## Design Exception #3 Reducing the Buffer Area at MP 188 to 190

I-70 West Vail Pass Safety and  
Operations Improvements

**Issue Task Force Design Exceptions Meeting # 3**  
**August 2, 2021**

**Project Leadership Team Design Exceptions Meeting # 9**  
**August 6, 2021**

Exhibit C (3 of 3)-  
Context Sensitive Solution  
Median Design Exception  
Mile Post 188.8 to 190.1  
07-20-2021

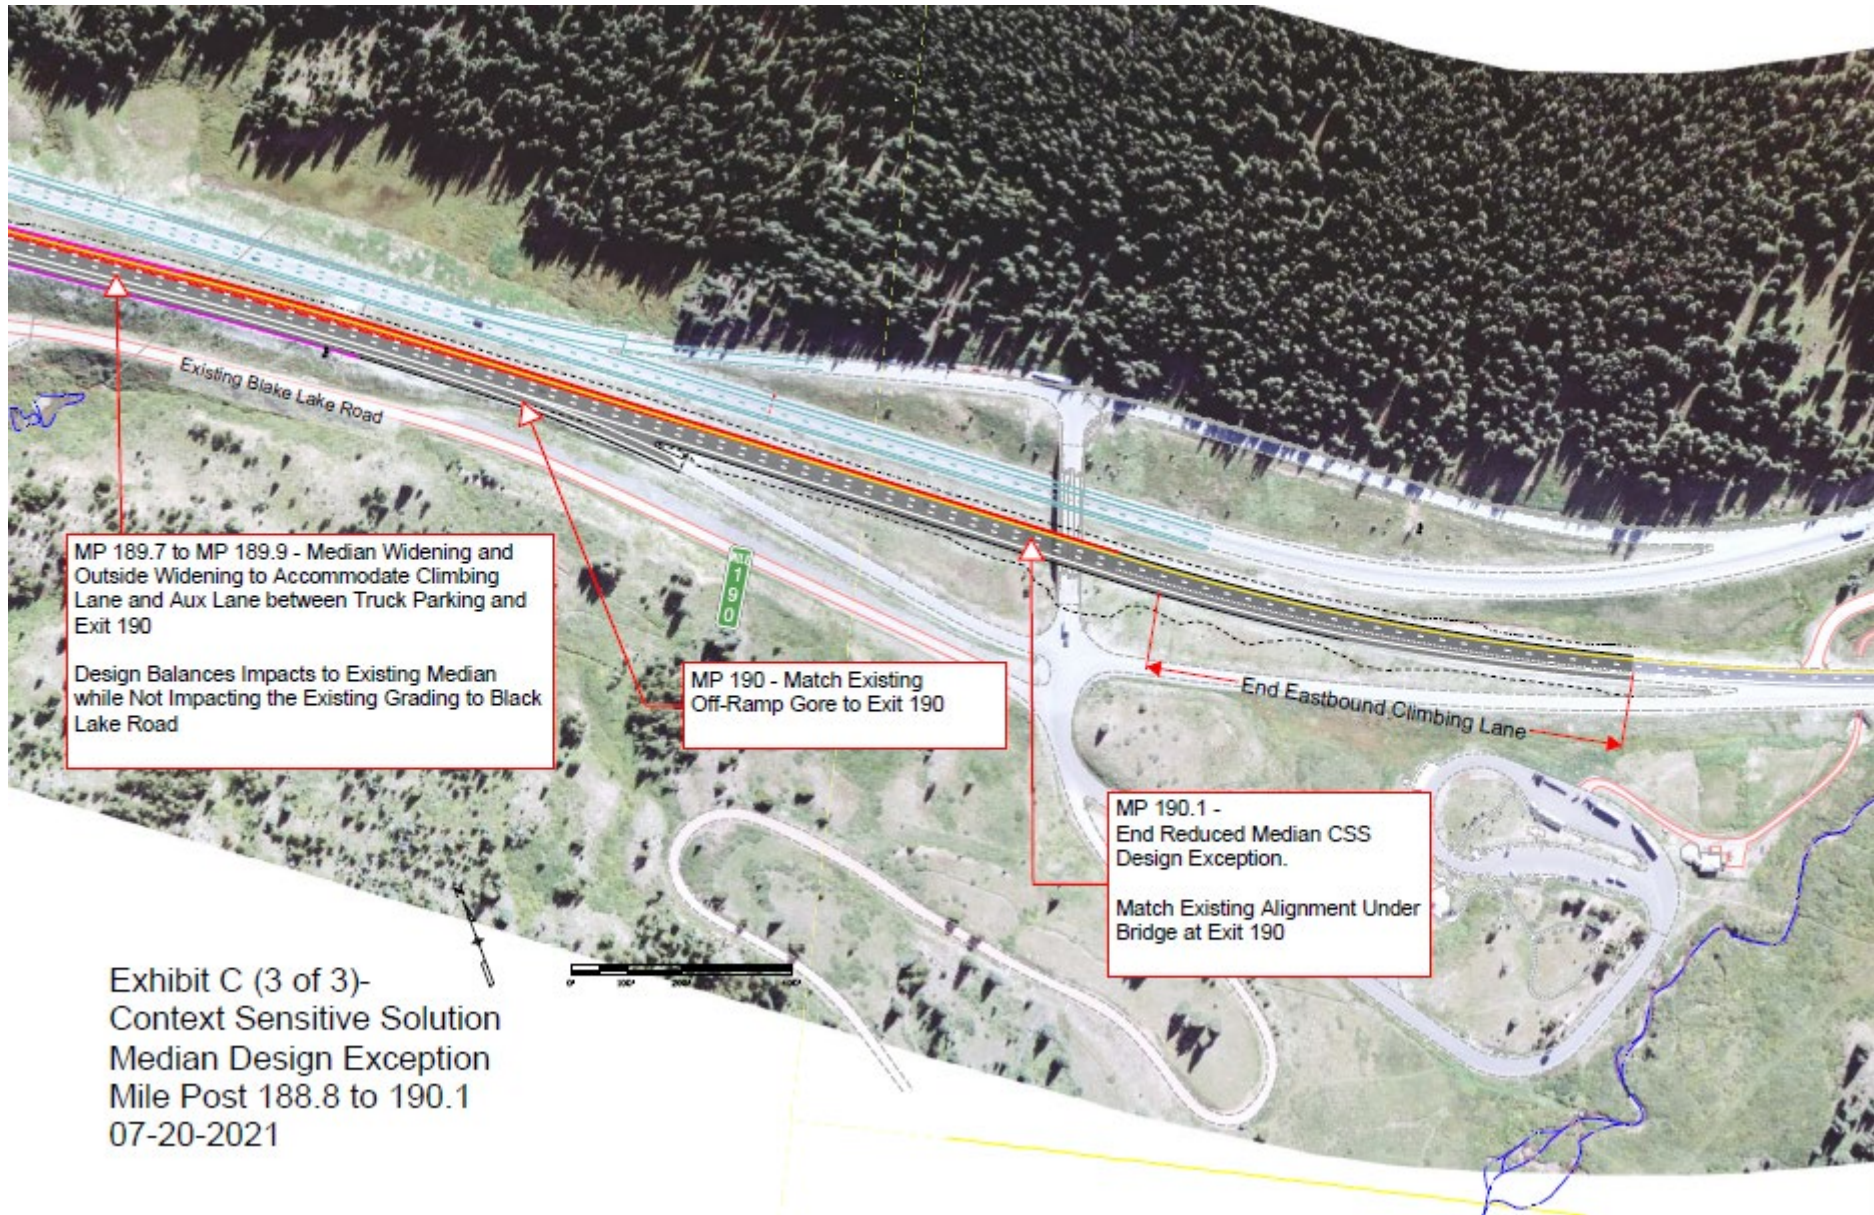
- Widening to the south would push the truck parking toward Black Lake No. 1 and the forested buffer between the parking and lake would be reduced.
- This change does not preclude the AGS alignment.

- d) The balance here is we have the truck parking on the outside and if we were starting to widen at all to the outside that starts to trigger into some significant walls and we would either need to build the final existing truck parking walls which are up to 30 feet high or we end up having some throw away walls.

Exhibit C (1 of 3)-  
Context Sensitive Solution  
Median Design Exception  
Mile Post 188.8 to 190  
07-20-2021

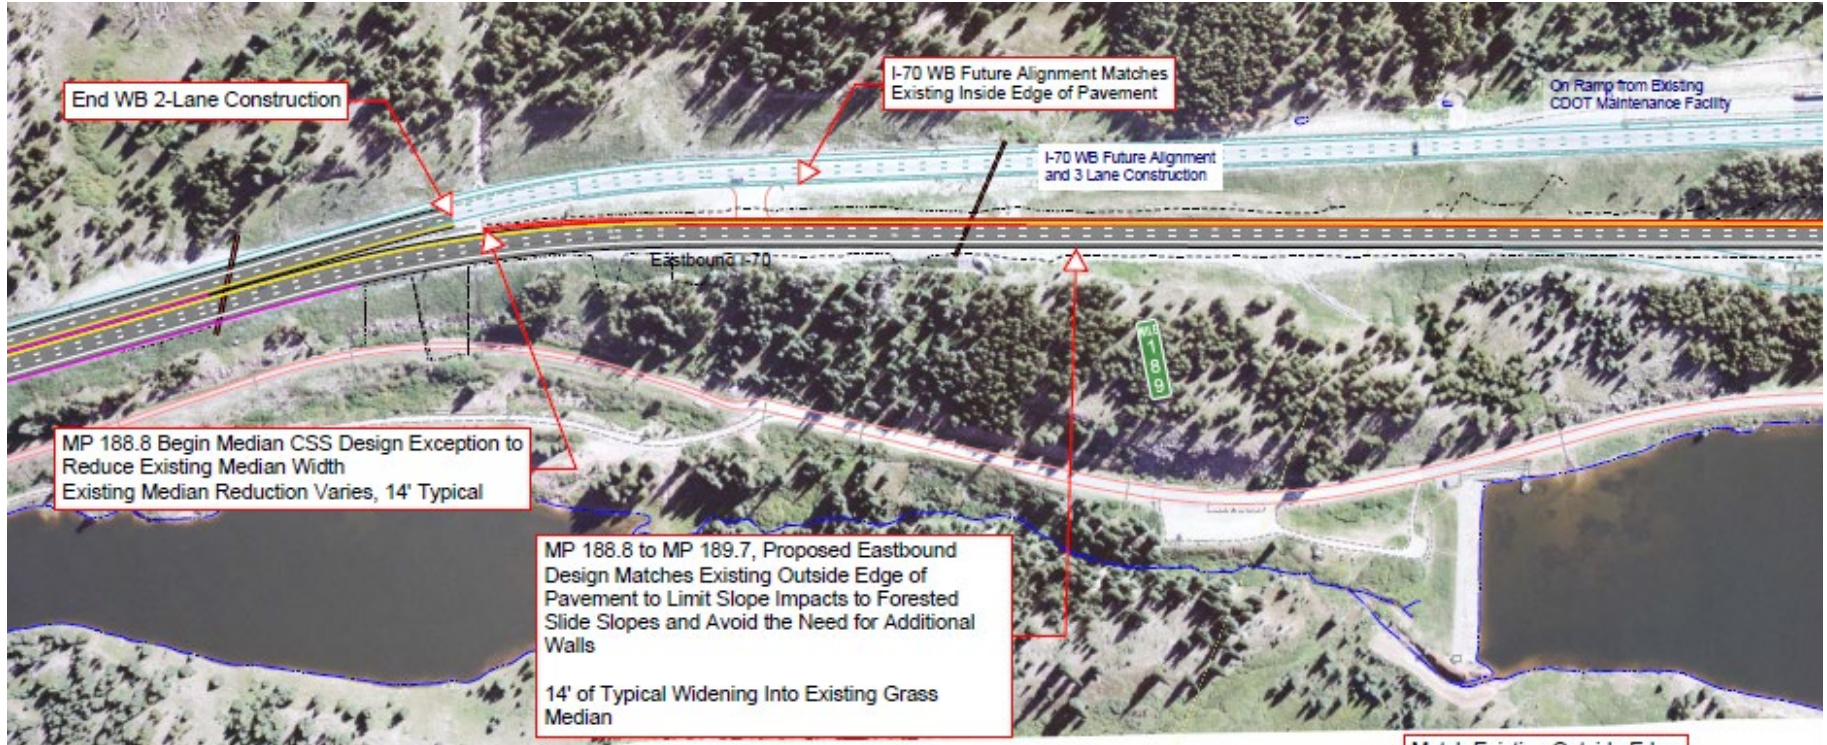
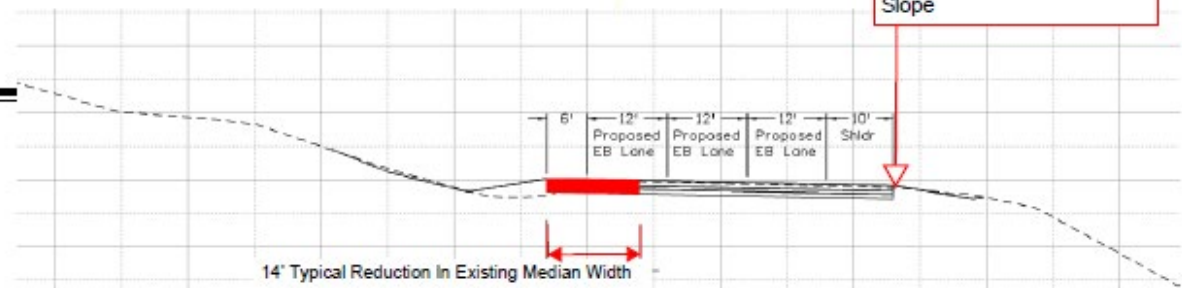
- i) This design exception is from MP 188.0 to MP 190.1. In this area we are holding the southern edge of pavement and widening into the median. It protects the slope, and the forested areas and we didn't want to get any closer to Black Lake. John said it will leave room for water quality features on the south side in those areas where we are still refining and designing right now. There is also another wildlife crossing that is in the area.

As we move farther long, if we push the roadway further south it generates larger and larger walls for the future truck parking expansion and push it farther into the forested area. Widening into the median helps to reduce that. John said they met with the Forest Service extensively throughout this process and they don't want us to encroach onto Black Lakes Road because that's currently where they have all their winter recreation parking. They park there for the summer as well, but it doesn't fill up as much. They wanted us to stay away from there for snow storage and to make sure they don't lose any parking.
